**METROPOLITAN GOVERNMENT OF NASHVILLE AND DAVIDSON COUNTY**

**STAFF RECOMMENDATION**  
**1316 Fourth Avenue North**  
**September 17, 2014**

**Application:** New construction-addition  
**District:** Germantown Historic Preservation Zoning Overlay  
**Council District:** 19  
**Map and Parcel Number:** 08209019000  
**Applicant:** Craig Kennedy, Architect  
**Project Lead:** Sean Alexander, sean.alexander@nashville.gov

**DEMOLITION PLAN**

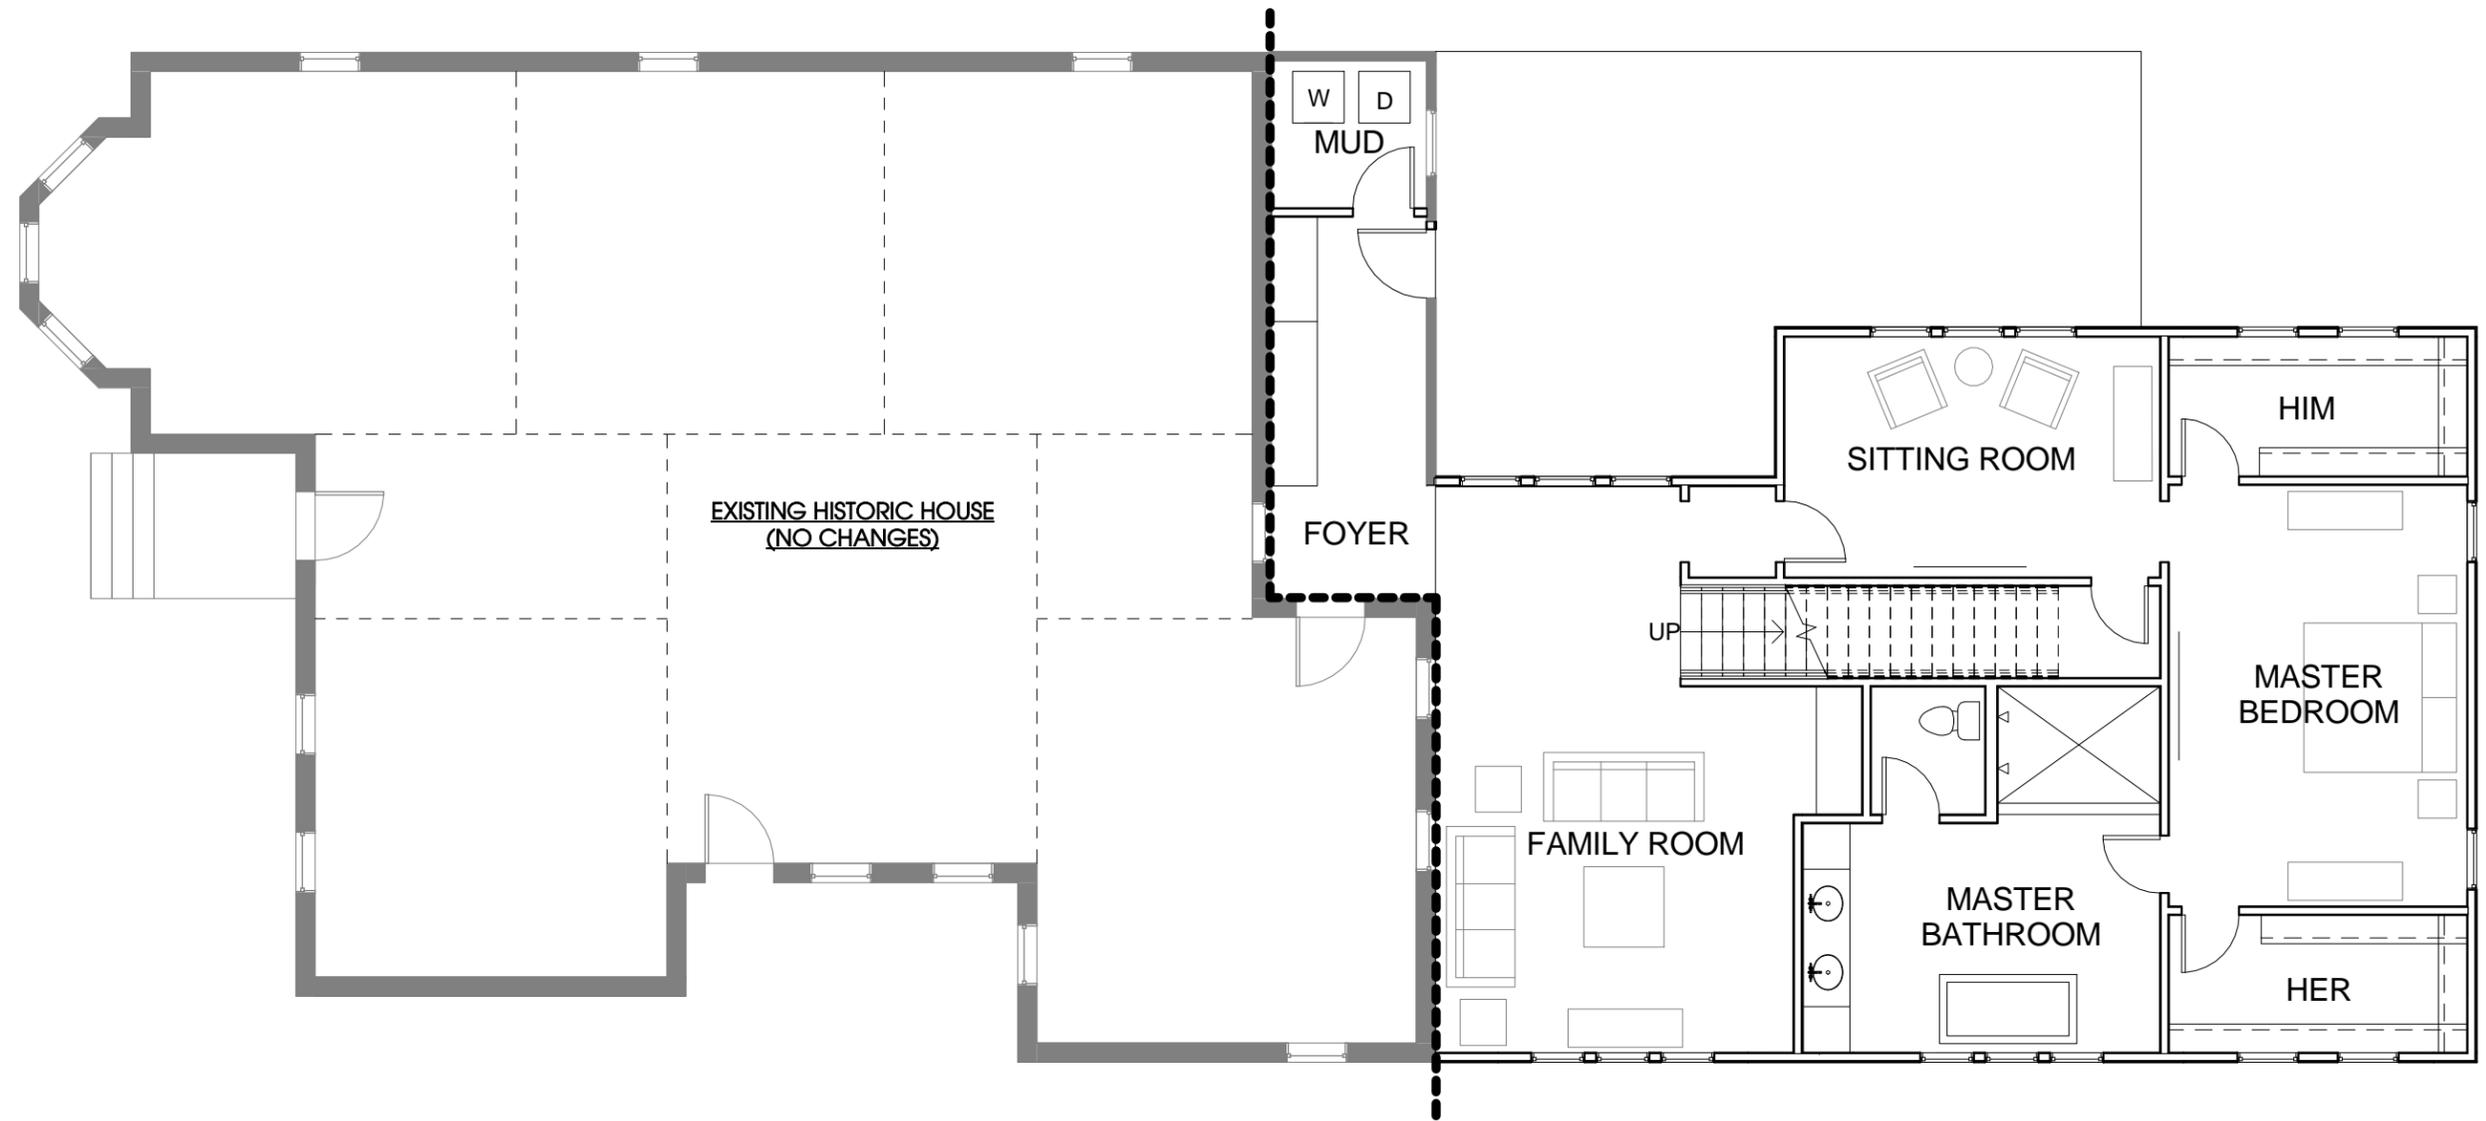
The existing rear addition, which was never completed, does not contribute to the historic character of the neighborhood. The demolition of this addition meets 7.2.2 for appropriate demolition and does not meet section 7.2.1 for inappropriate demolition.

**1 NORTH (SIDE) ELEVATION**

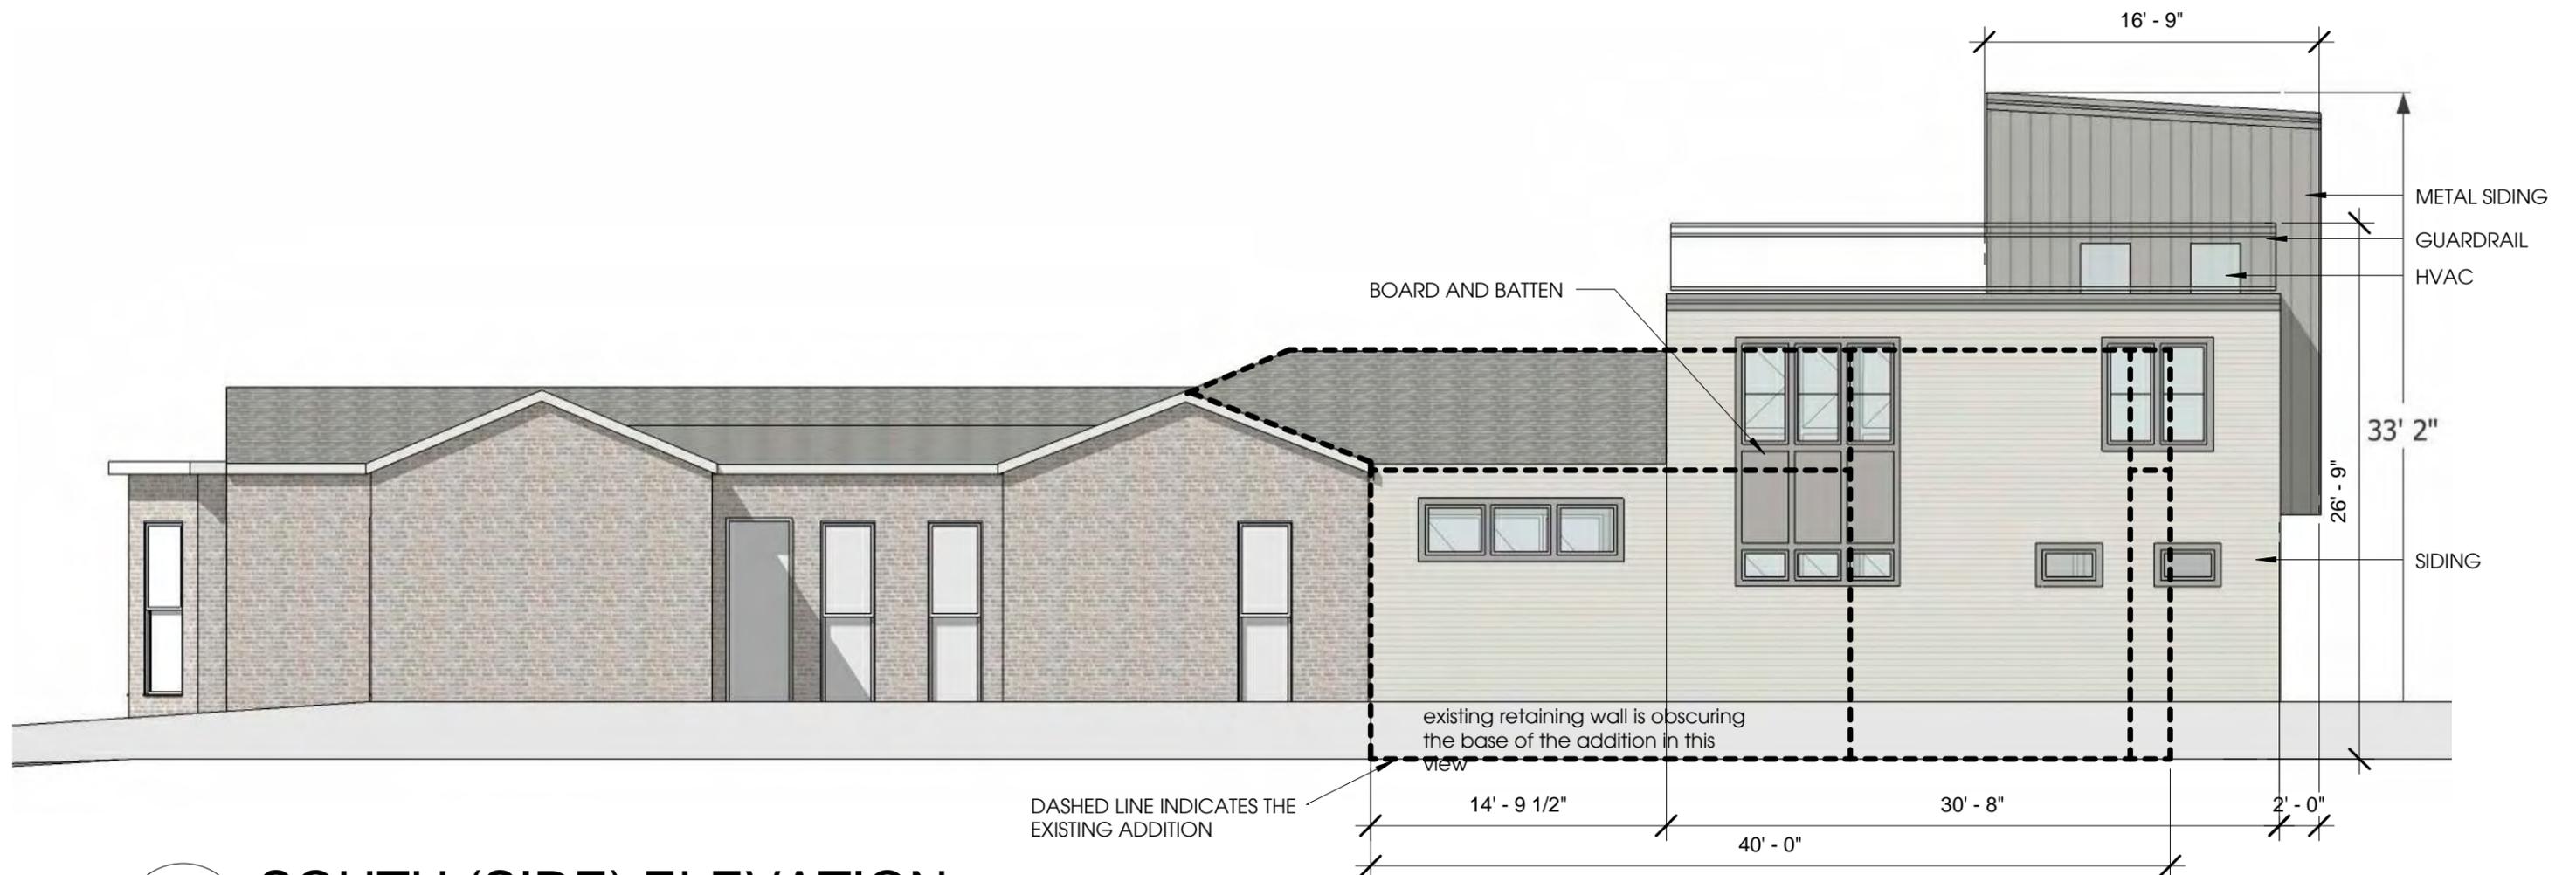
The new addition will retain a portion of the existing addition where it meets the rear of the existing house. This addition does not set in from the sides of the house, but has a different exterior material to distinguish it from the historic building. This meets design guideline 4.2.3. The addition will extend back forty-six feet (46'), which is seven feet (7') further than the existing addition. On the left side, the addition will extend back fifteen feet (15') before stepping out six feet (6') to the left, and then continuing the remaining thirty-one feet (31'). The right side will be a straight wall without setting in, as it is with the existing addition.

The new addition will tie into the roof of the existing addition, a rear-oriented gable that sits two feet (2') taller than the original roof. Starting twenty-three feet (23') back from the rear of the original structure, or seventy-one feet (71) feet from the front of the house, the addition will rise to two-stories tall. The roof of this section of the addition will be flat with a deck four feet (4') above the peak of the original house, with four foot (4') high steel cable guardrail on top. This section continues back another sixteen feet (16') to where the third story begins. This third story of the addition will also have a flat roof topping out at thirty-three feet (33') tall, or fifteen feet (15') taller than the historic house. The walls of the third story will sit in from the side walls of the original house by ten feet (10') on the left side and six feet (6') on the right.

The primary exterior material of the addition will be smooth-faced cement fiberboard with a five inch (5") exposure with cement-fiber trim and board and batten accent panels between the first and second story windows, with vertical seamed metal siding on the walls of the upper story. Staff finds cement-fiberboard to be an acceptable substitute for wood siding because it is similar in scale, appearance, and durability. Standing seam metal is also a common material in the historic mixed residential and industrial area, used most often as a roofing material. A portion of the roof will be asphalt shingle to match the roof on the historic houses, and the foundation will be split-faced concrete block. The material of the doors and windows is not known at this time, and must be approved prior to purchase and installation. With a condition that the unknown materials are approved administratively, Staff finds that the known materials are compatible with the historic house and meet guidelines 2.4.1.

**2** EAST (BACK) ELEVATION

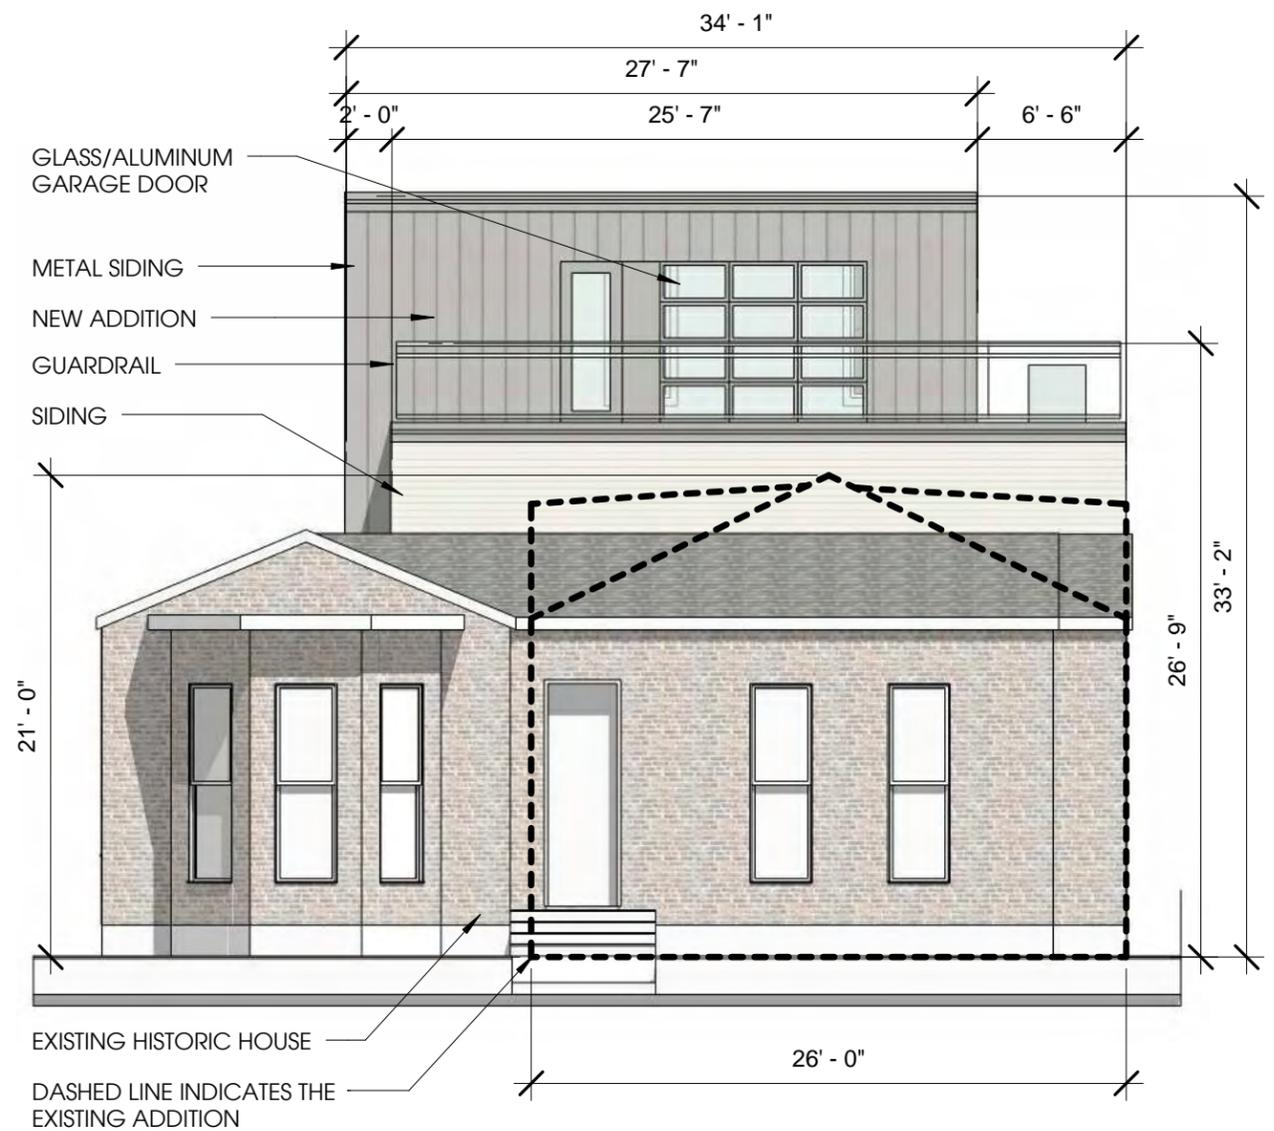
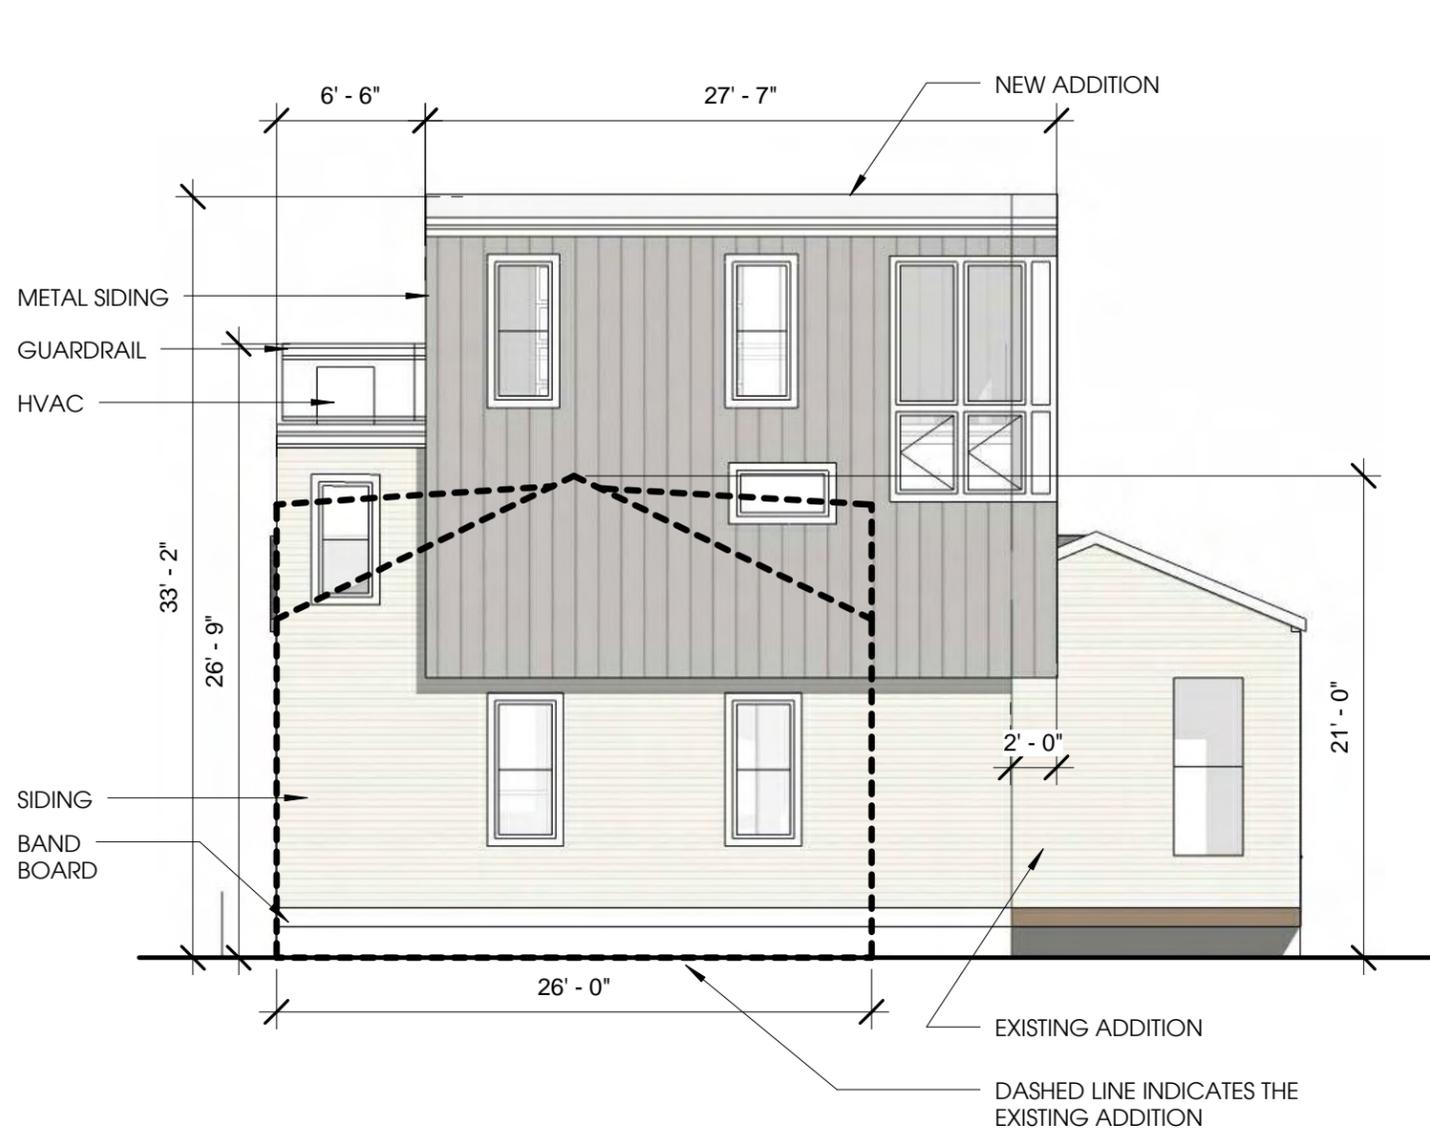
The windows on the proposed addition are all generally twice as tall as they are wide, which is compatible with the proportions of openings on comparable historic buildings. There are no large expanses of wall space without a window or door opening. Staff finds the project's proportion and rhythm of openings to meet sections 2.5 and 2.6 of the design guidelines.

With modern materials and the flat roofs, the addition will be very contemporary compared to the traditional architecture of the Italianate style historic house. Because the addition is situated entirely to the rear of the original structure and will not destroy or obscure significant architectural features of the historic house, and because it will sit far enough back from the front of the house that it will not impact views of the house, Staff finds that the proposal meets guideline 4.2.5.

Staff recommends approval of the application to construct a rear addition to the historic house with the condition that the selections for windows and doors are approved prior to ordering. Meeting that condition, Staff finds that the proposal meets the applicable sections of the Germantown Historic Preservation Zoning Overlay.
